BID ADDENDUM NO. 2

January 29, 2025
Horseheads Central School District
Ridge Road Elementary School
HUNT #: 1923-060

The following Addendum items shall be considered as part of the contract documents prepared by HUNT ENGINEERS, ARCHITECTS, LAND SURVEYORS & LANDSCAPE ARCHITECT, DPC.
Bid Document date of January 13, 2025

ONE-LINE DIAGRAM - NEW WORK
RIDGE ROAD ELEMENTARY ADDITION & ALTS
HORSEHEADS CENTRAL SCHOOL DISTRICT
 112 RIDGE RD, HORSEHEADS, NY 14845
E3.4
 PROJECT NO: 1923-060

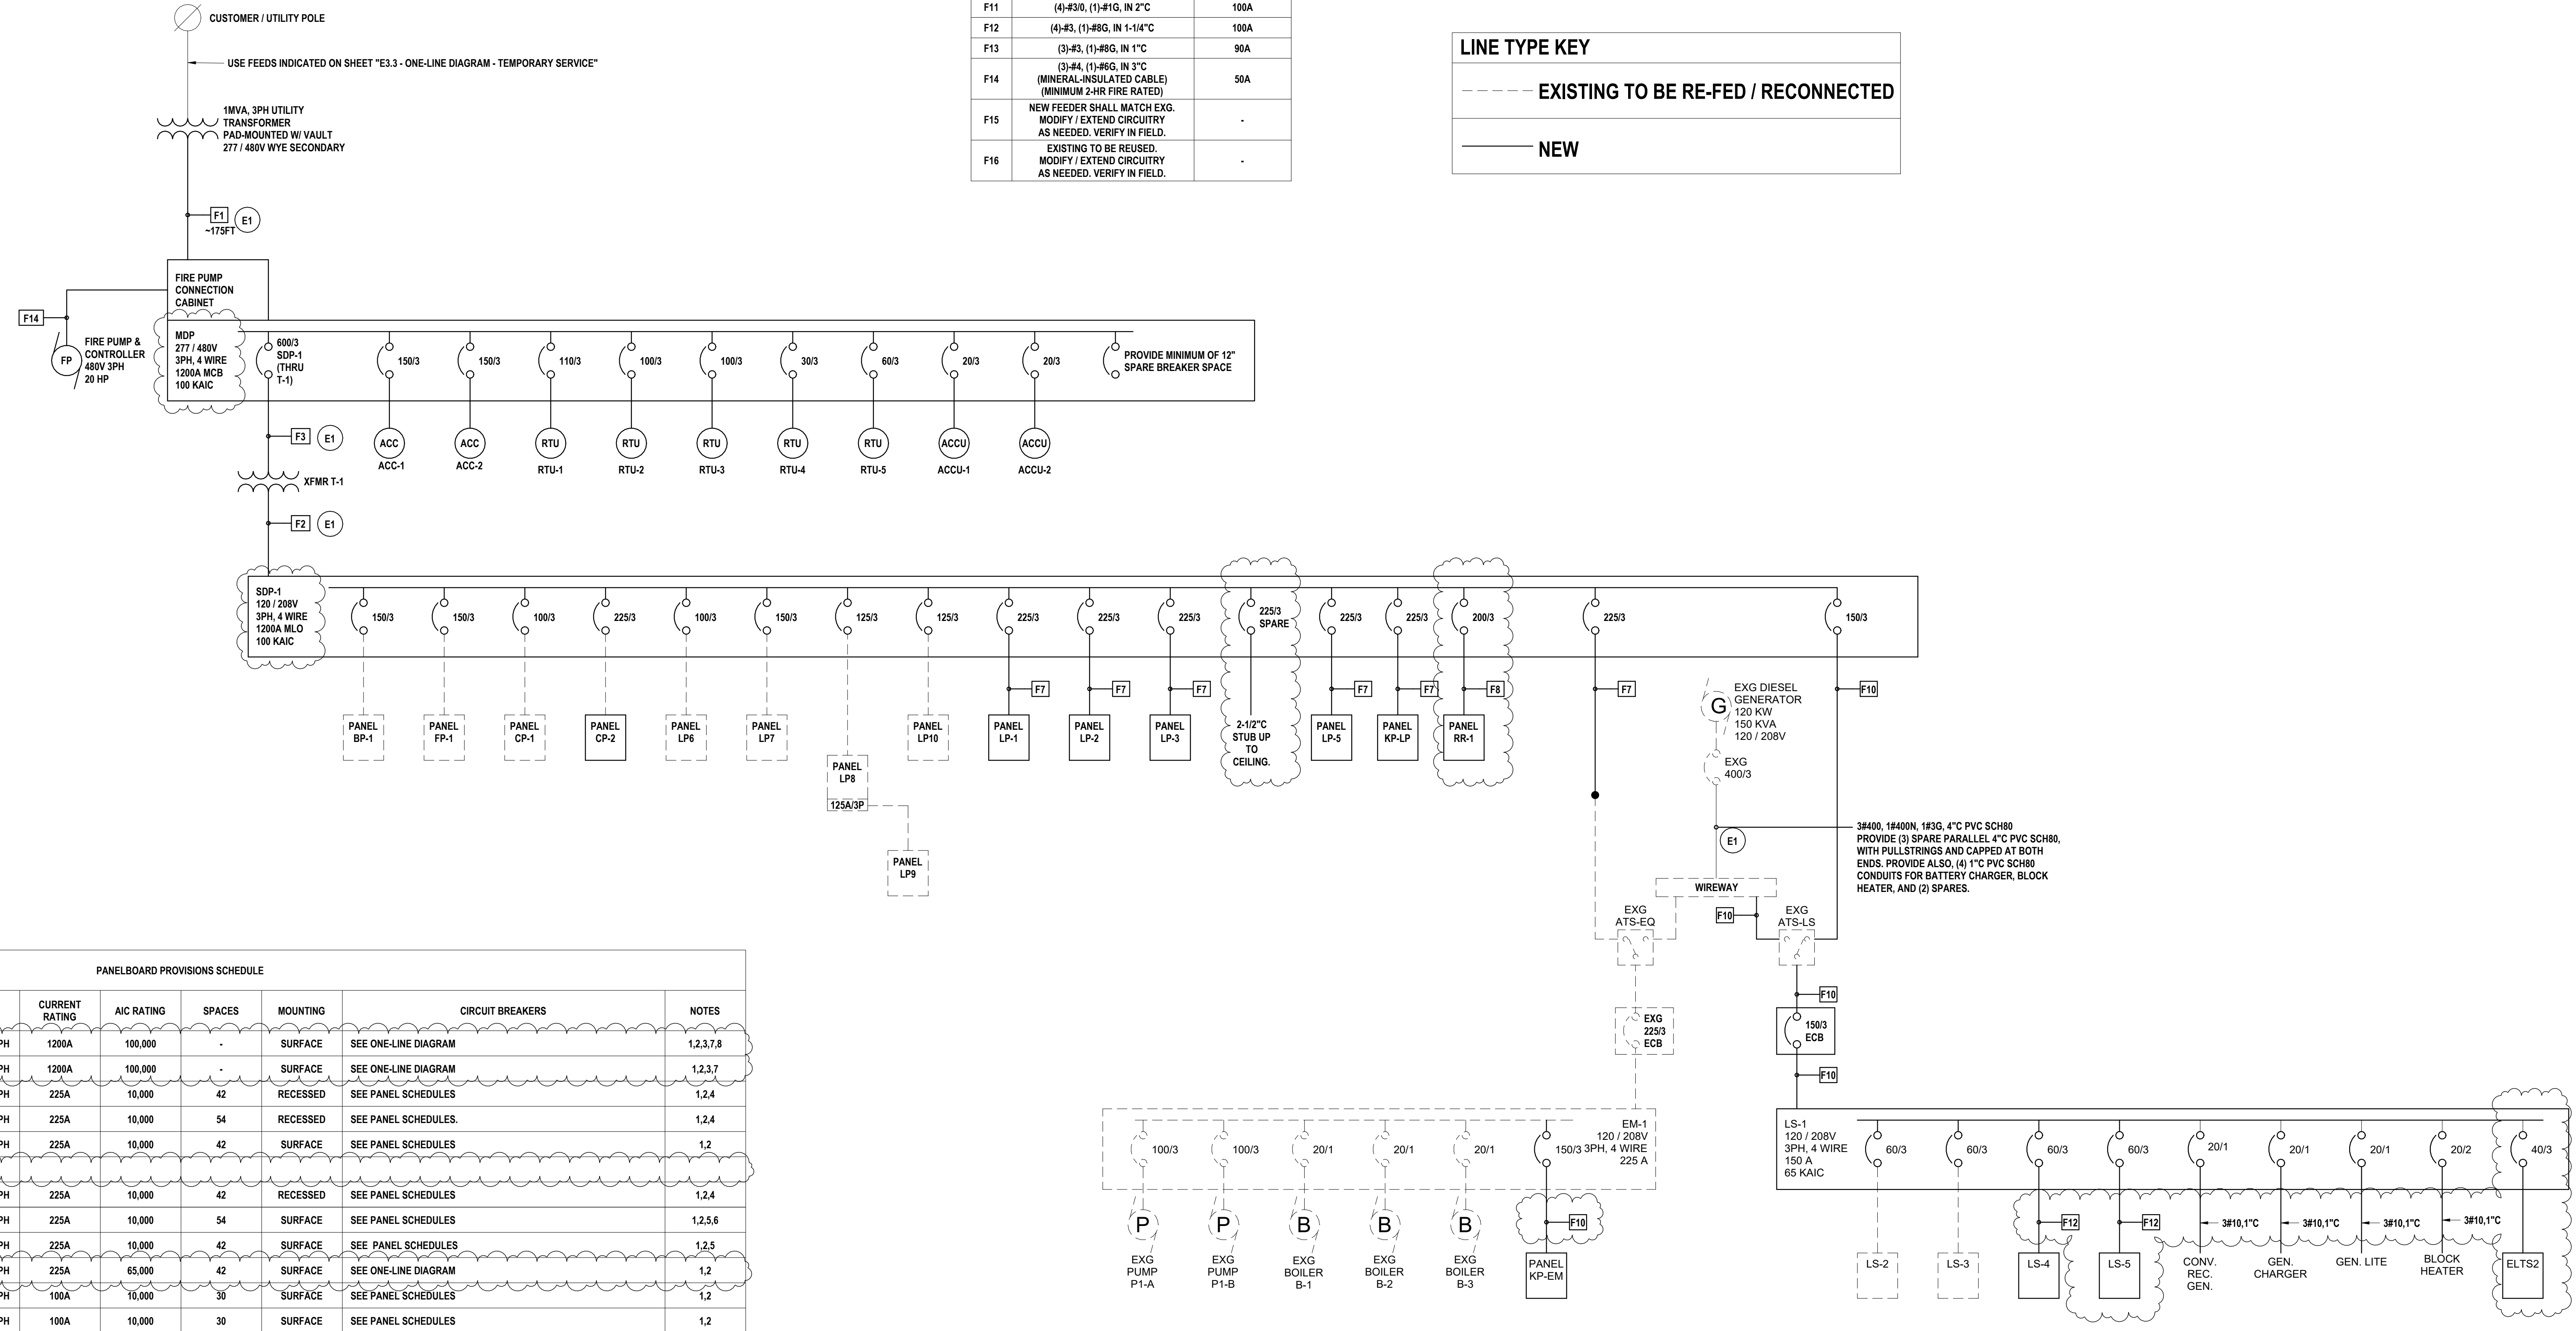
ITEM AD2-5 Refer to Drawing E3.4 - ONE-LINE DIAGRAM - NEW WORK

DELETE SHEET "E3.4 - ONE-LINE DIAGRAM - NEW WORK" AS ORIGINALLY ISSUED

ADD SHEET "E3.4 - ONE-LINE DIAGRAM - NEW WORK" BY THIS ADDENDUM
